February 11, 2019

**RE: Woodward Road Improvements
Drainage Report for Work Order
Engineer's Stamp Date: none (report dated 8/6/18)
Hydrology File: M14D035**

Woodward Road Improvements 2nd Street to Broadway Boulevard

Preliminary Drainage Report

Figure 4
Woodward Road
Improvements
CN A300161
2nd St. to Railroad Tracks

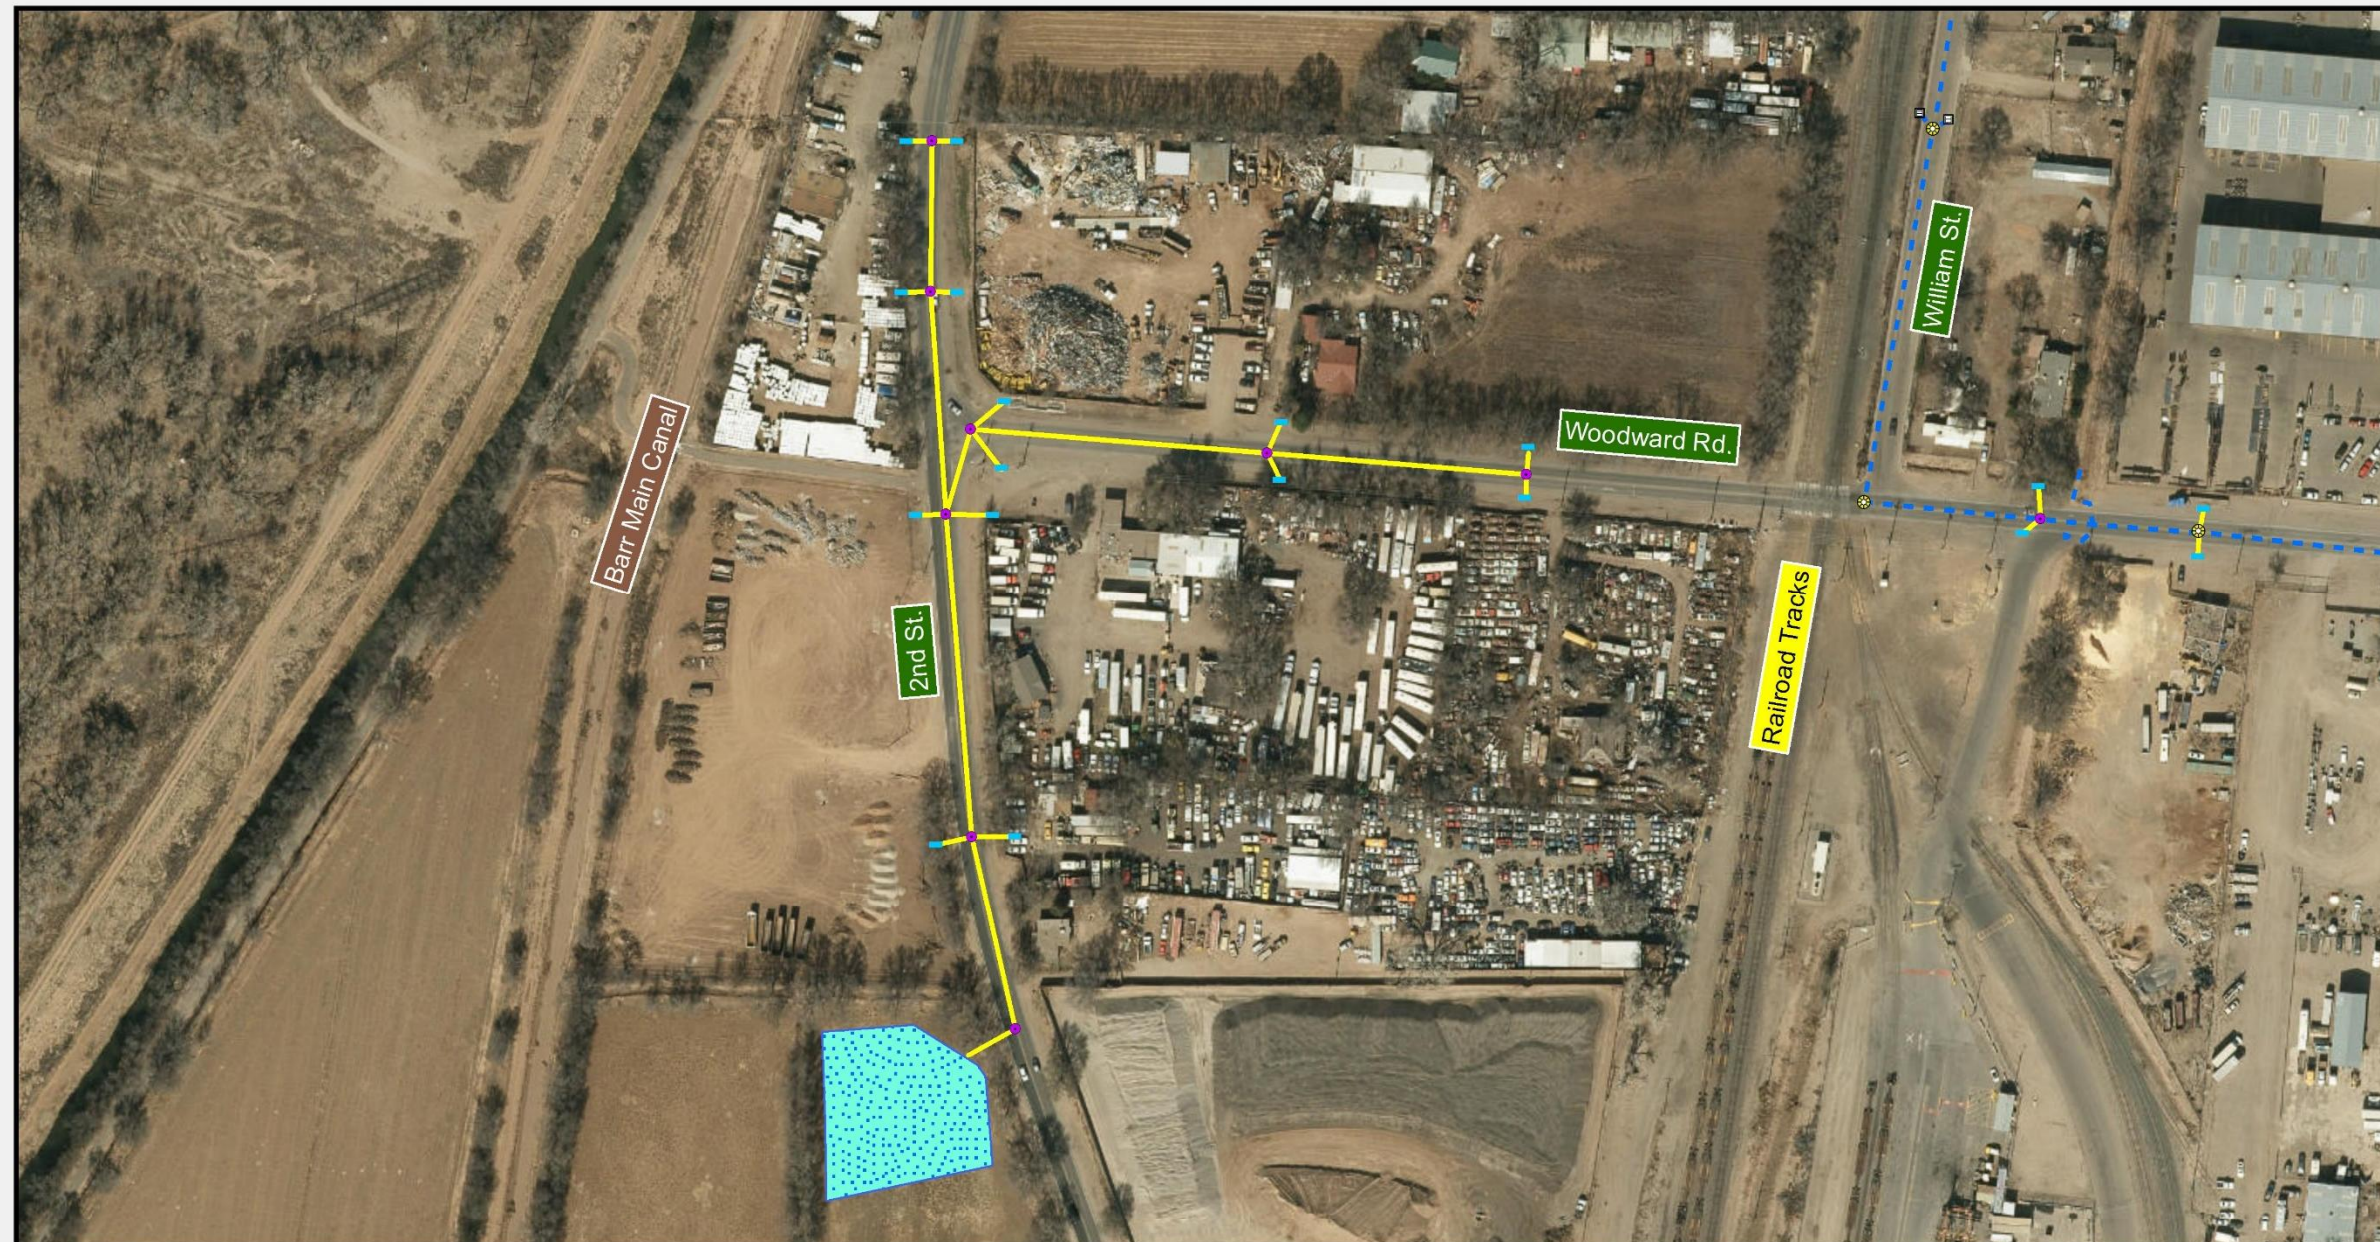
3. Include the design of the proposed pond on 2nd St in the DRC plans and the Drainage Report, unless the alternate plan to discharge to the Riverside Drain is approved by the MRGCD. Who will be maintaining the pond? If County, a maintenance agreement or an [Agreement and Covenant](#) will be required prior to work order approval and must address vector control. The pond needs to be sized to retain the 10-day, 100-yr storm below the soffit of the inlet pipe. The 10-yr water surface should be used as the beginning water surface for determining the HGL in the upstream pipes. This control surface should also be used when determining 10-yr velocities in compliance with Ch22.3.B.3.g.

WOODWARD ROAD
PROPOSED STORM DRAIN
IMPROVEMENTS - PLAN

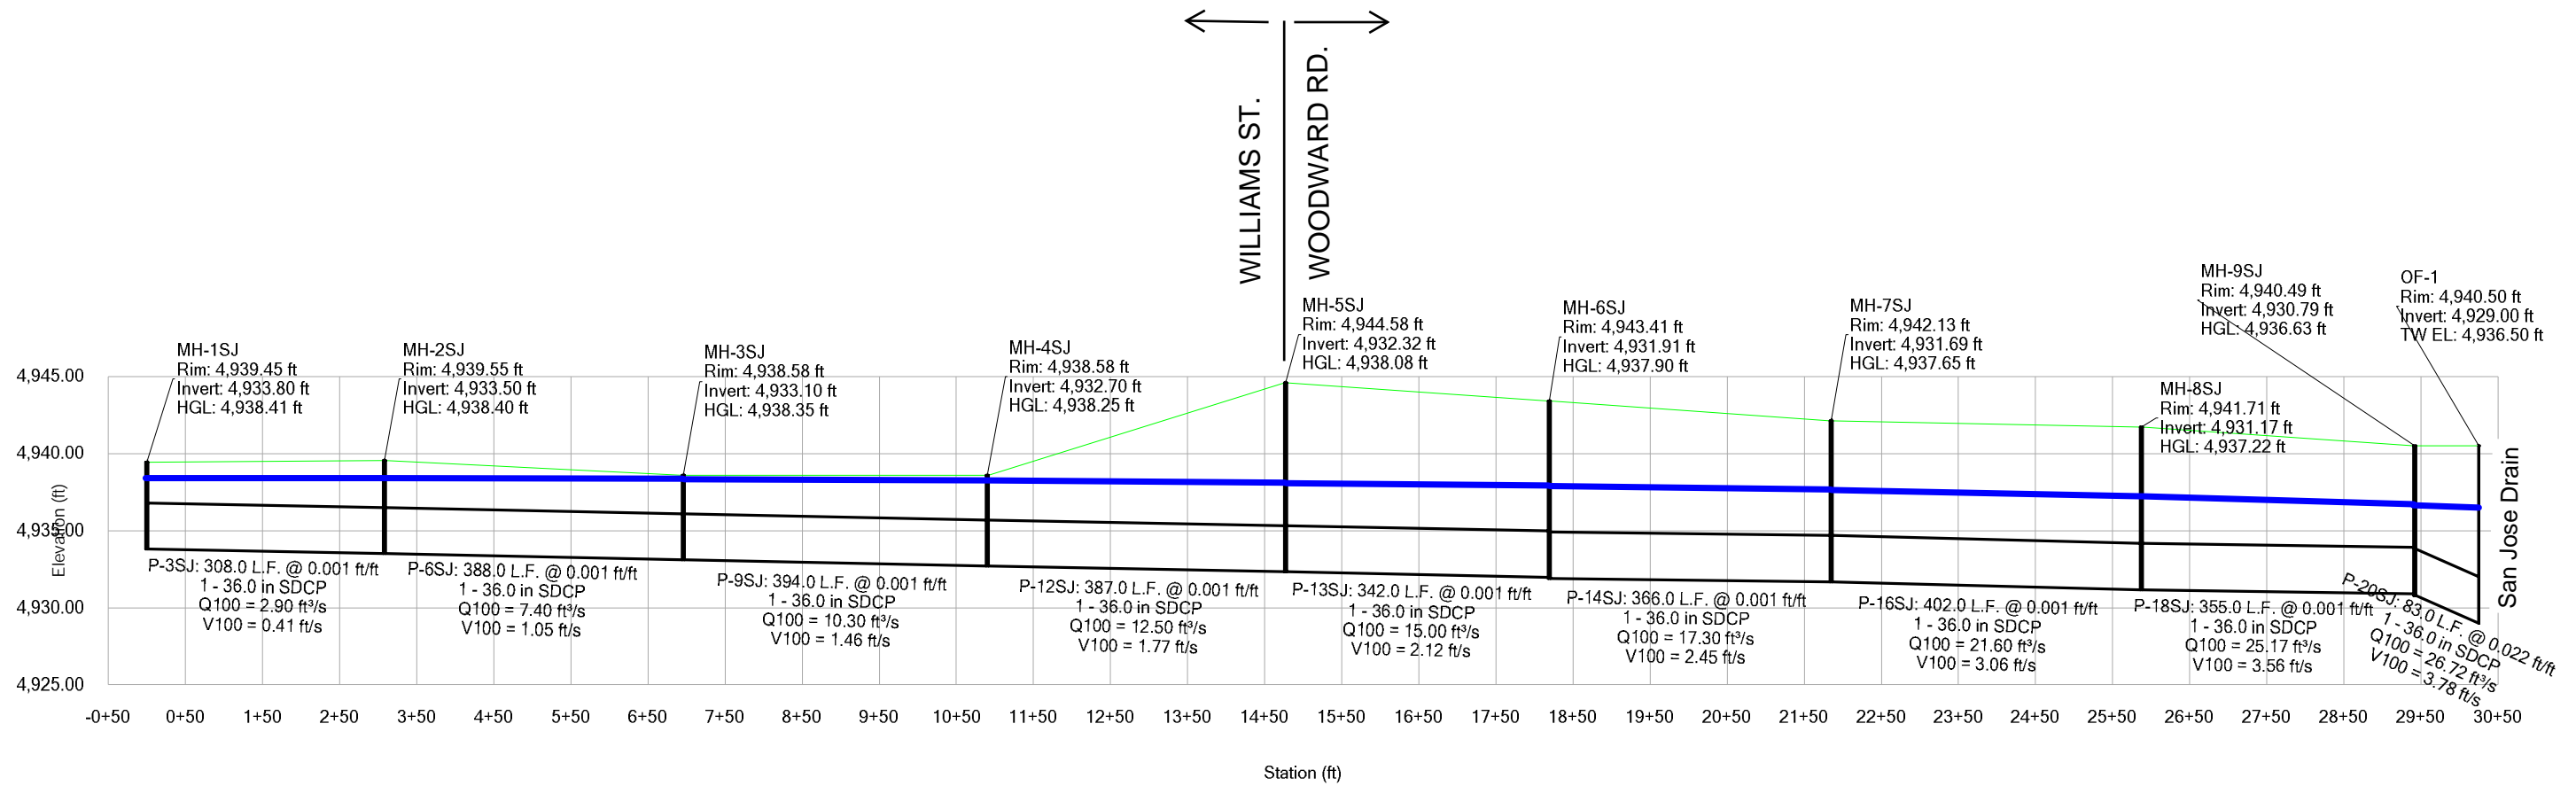
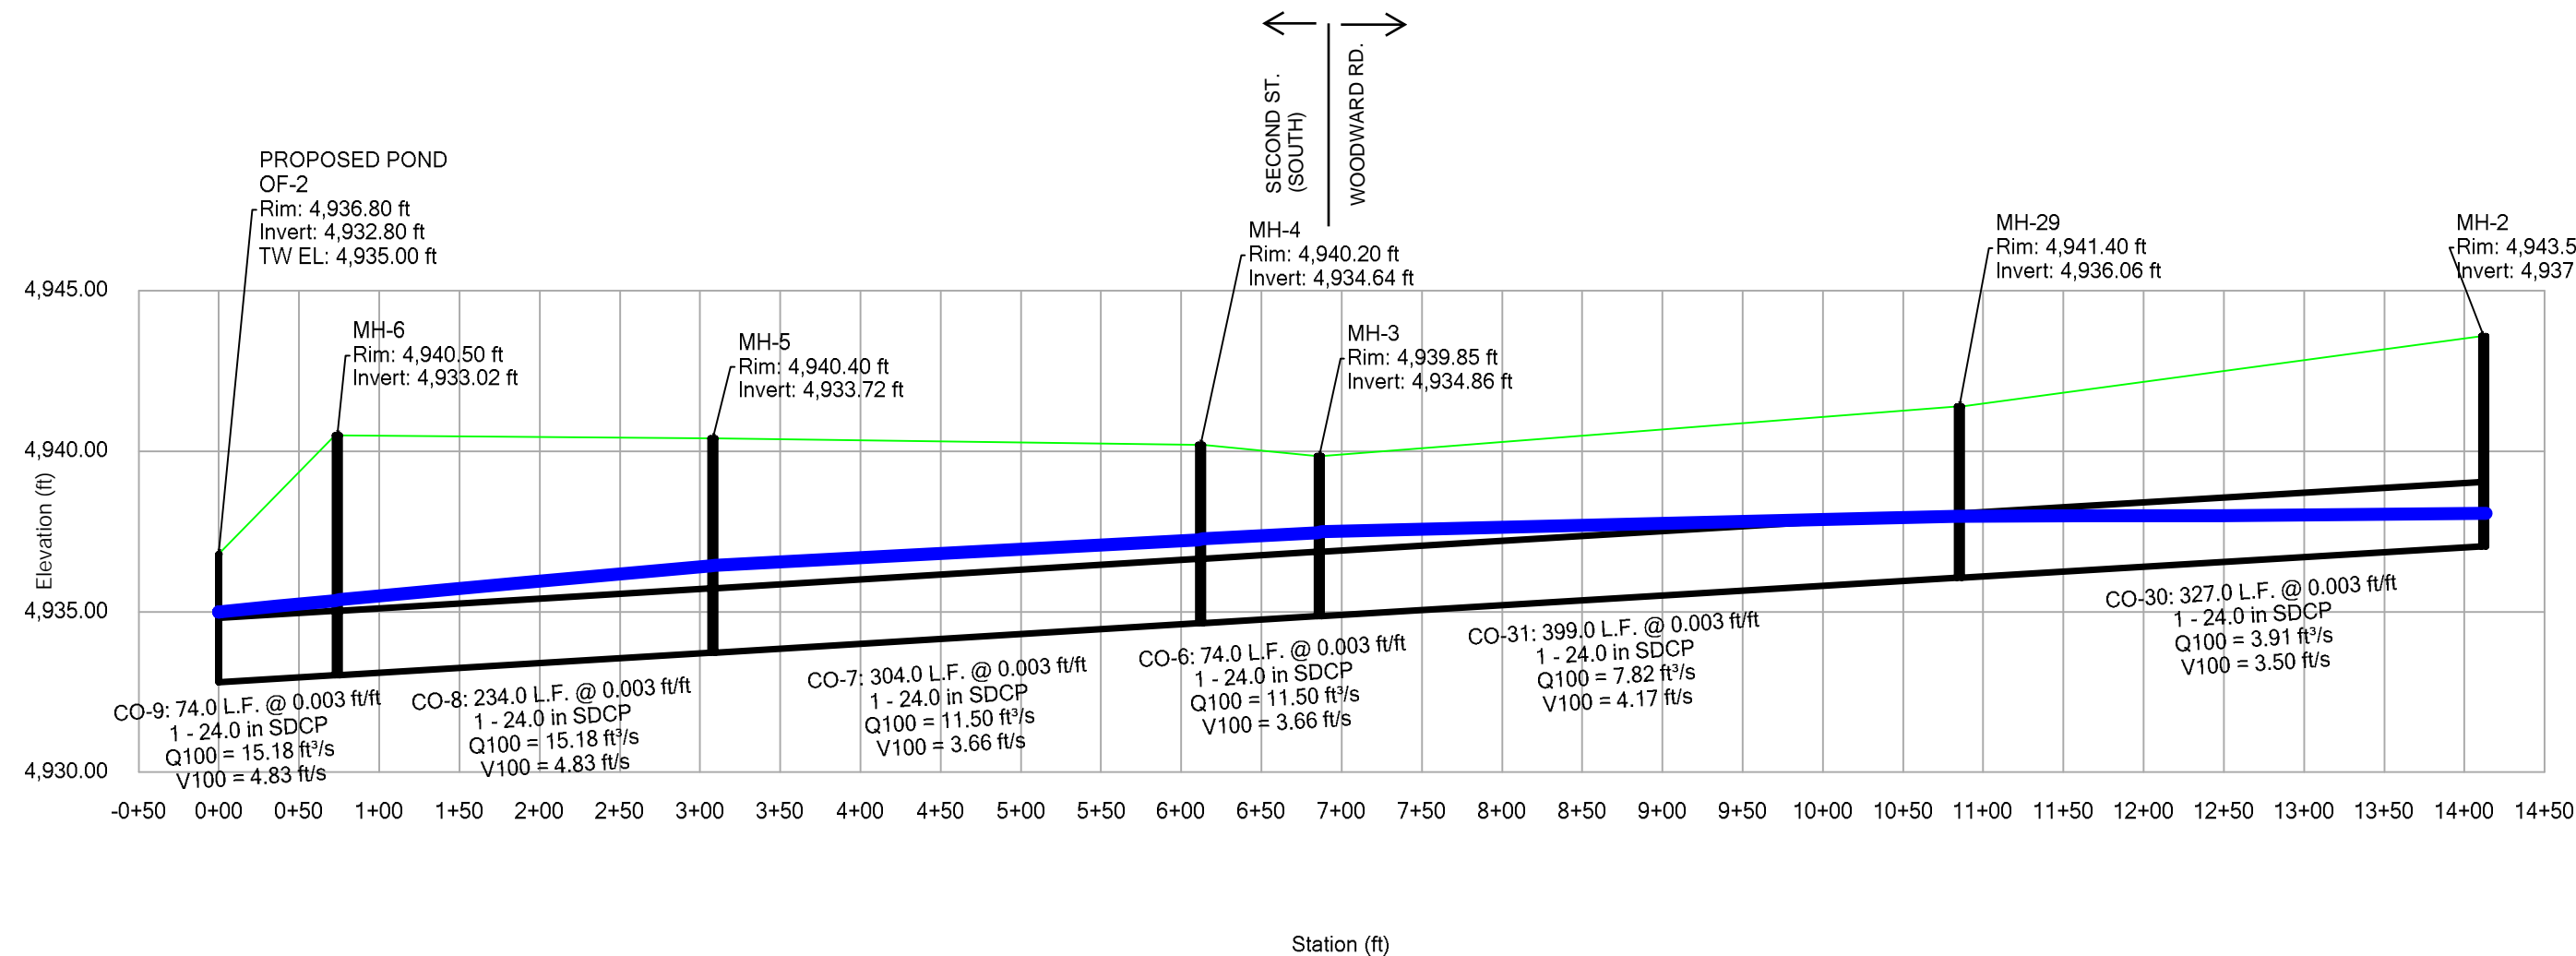
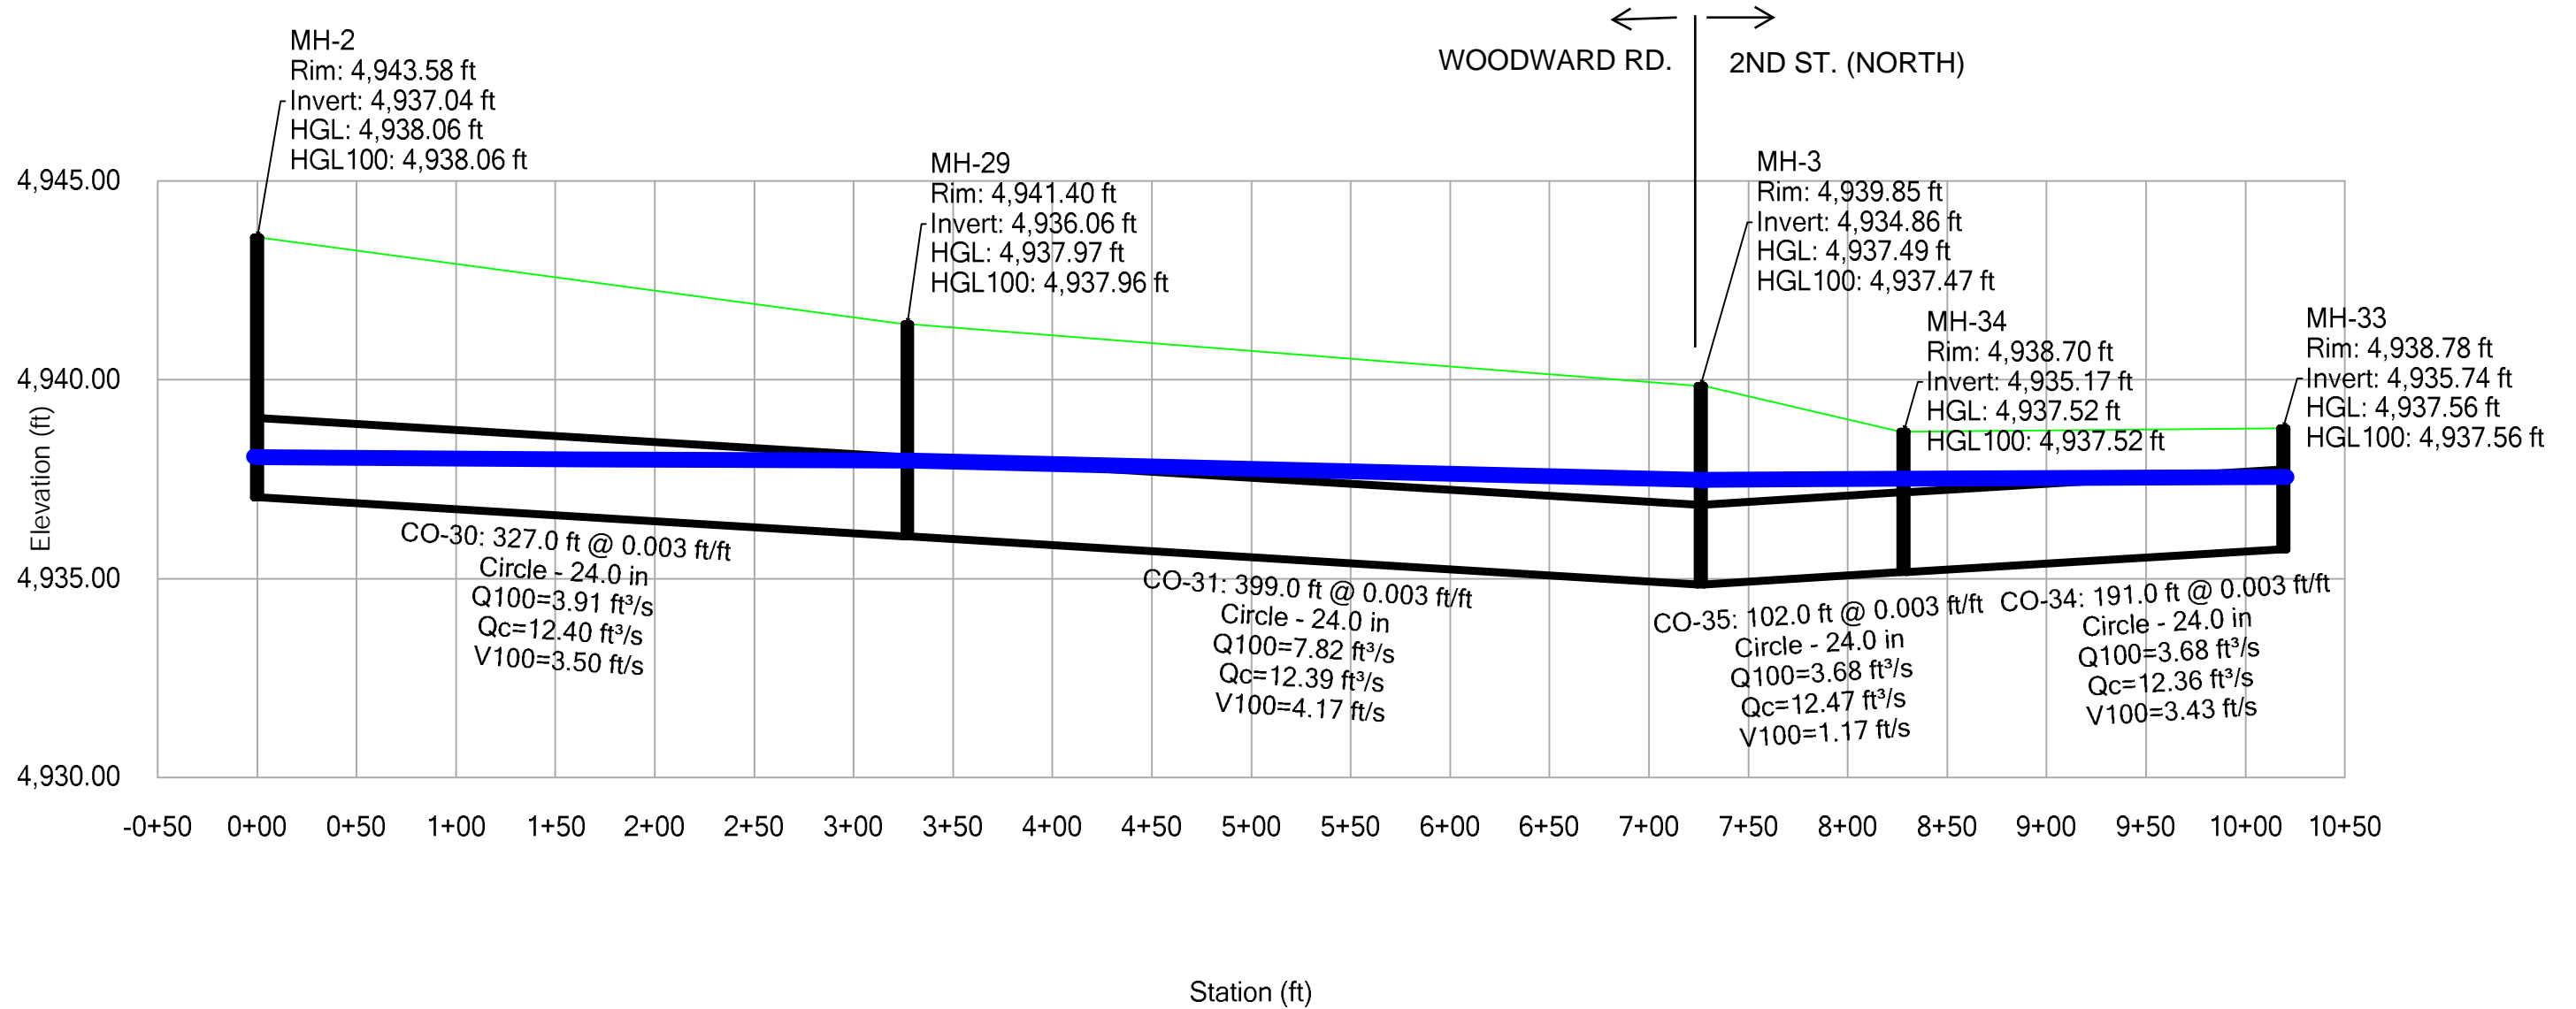
4. Hydraulic grade lines need to be calculated along the energy grade line per the DPM Ch22.3.B. Provide the EGL on the pipe profiles or in the supporting tables; confirm RCP is the pipe type being modeled. In preparing the pipe network, be sure to comply with Ch22.3.B.3.f and g.: *Minimum Pipe Size* and *Minimum Slope*.

6. The 10-yr water surface in the San Jose Drain should be used as the beginning water surface for determining the HGL in the upstream pipes along Woodward/Williams. This control surface should also be used when determining 10-yr velocities in compliance with Ch22.3.B.3.g.
